## UNITED STATES OF AMERICA BEFORE THE FEDERAL ENERGY REGULATORY COMMISSION

)	Project No. P-2082-062
)	
)	
)	
)	Project No. P-14803-000
	) ) ) )

### PACIFICORP'S RESPONSES TO ADDITIONAL INFORMATION REQUEST QUESTION NOS. 7, 8, 9 AND 11

Normal Full Pool Elevation (HWL). Elevations are referenced to USGS Datum (NGVD 1929).

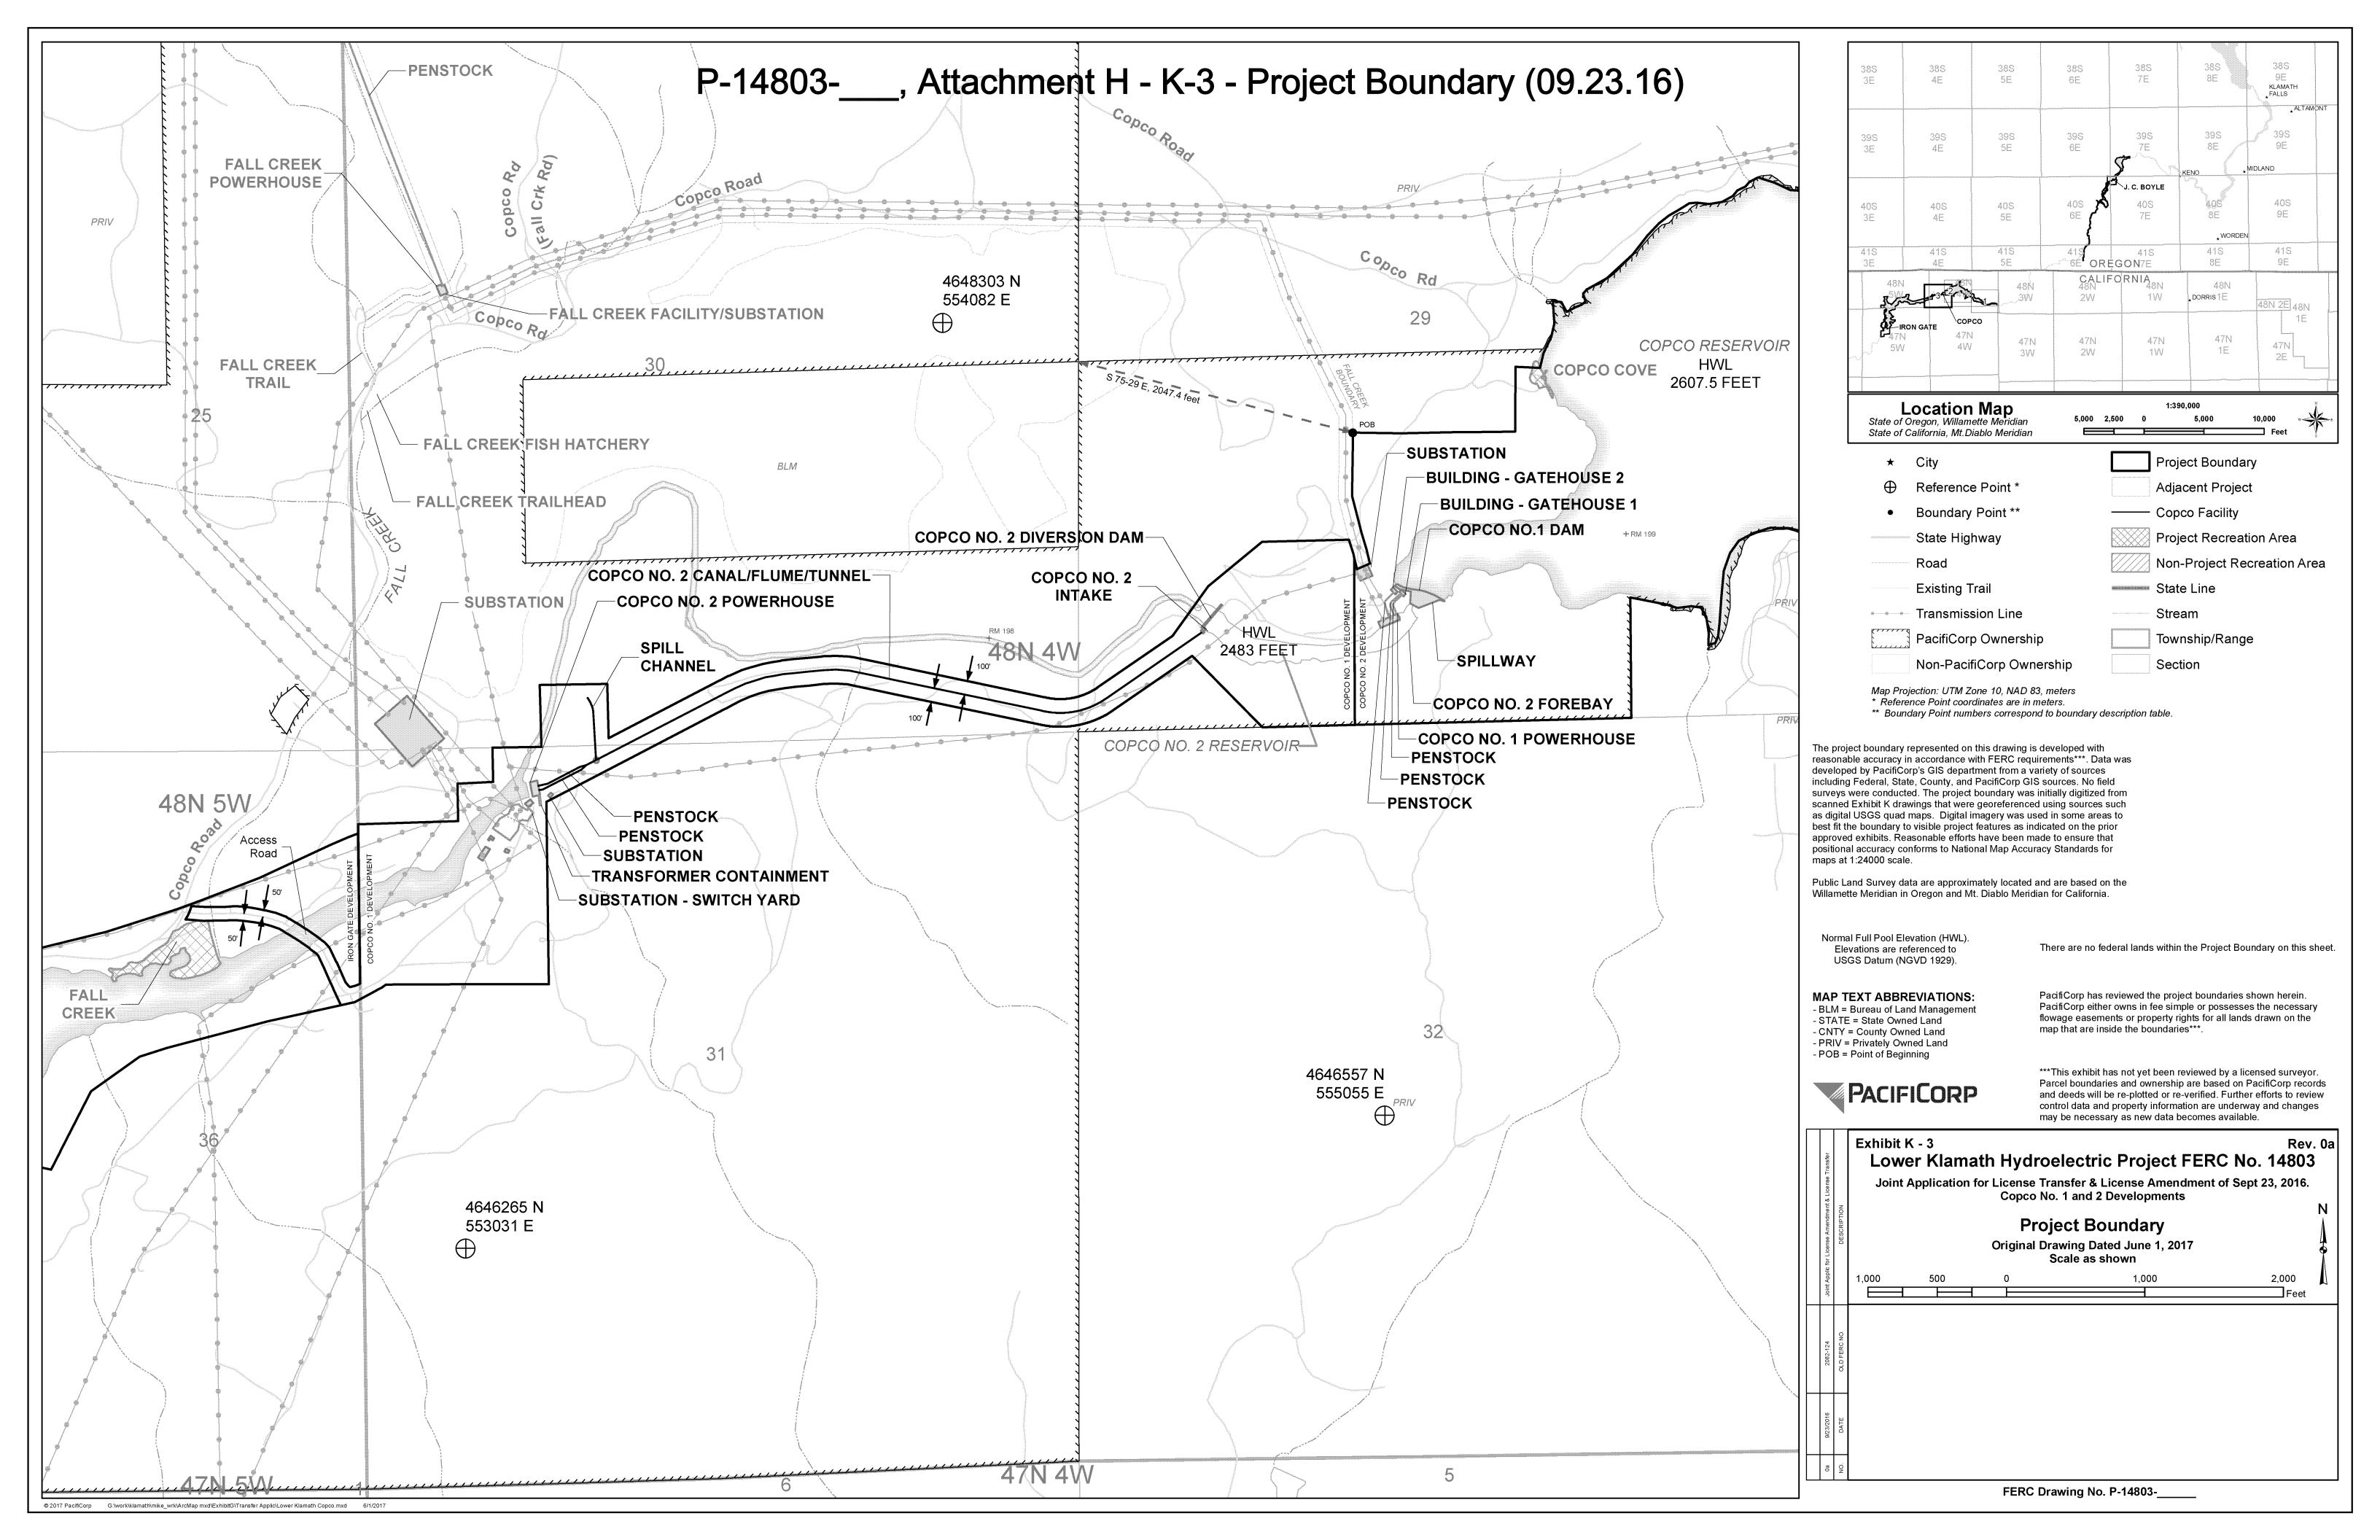
Pursuant to the Commission's regulations at 18 CFR, section 4.201 (c), the amendment application must contain those exhibits that require revision in light of the nature of the proposed amendment. Therefore, the licensee must include with the amendment application revised exhibits F and G to reflect the proposed changes. Please refer to the attached list of current exhibit drawings under the license, and provide revised exhibits accordingly. Any exhibit drawings must be prepared in accordance with 18 CFR sections 4.39 and 4.41 (g) and (h).

Attached to this AIR response as Attachment H are provisional project boundary drawings that provide additional detail on the proposed boundary changes. To date, PacifiCorp has determined that three drawings require revisions in light of the proposed amendment. These are drawings 2082-124, 2082-125, and 2082-228, which represent the separation of the Copco and Fall Creek developments. PacifiCorp has prepared these provisional drawings to more clearly define the boundaries for the Klamath Hydroelectric Project and the new Lower Klamath

This revised project boundary exhibit was prepared for the application for amendment and partial transfer of the license for the Klamath Hydroelectric Project (FERC No. 2082). It supersedes the current exhibit sheets for the area where the Klamath Hydroelectric Project and the proposed Lower Klamath Project (FERC No. 14803) adjoin. The project boundary on this exhibit represents the same project boundary as shown on the approved Exhibit K sheets for the Fall Creek, Copco No. 1, and Copco No. 2 developments of the existing Klamath Hydroelectric Project, and adds the separate project boundaries where the Fall Creek transmission line corridor connects to the substation northwest of the Copco No. 1 powerhouse.
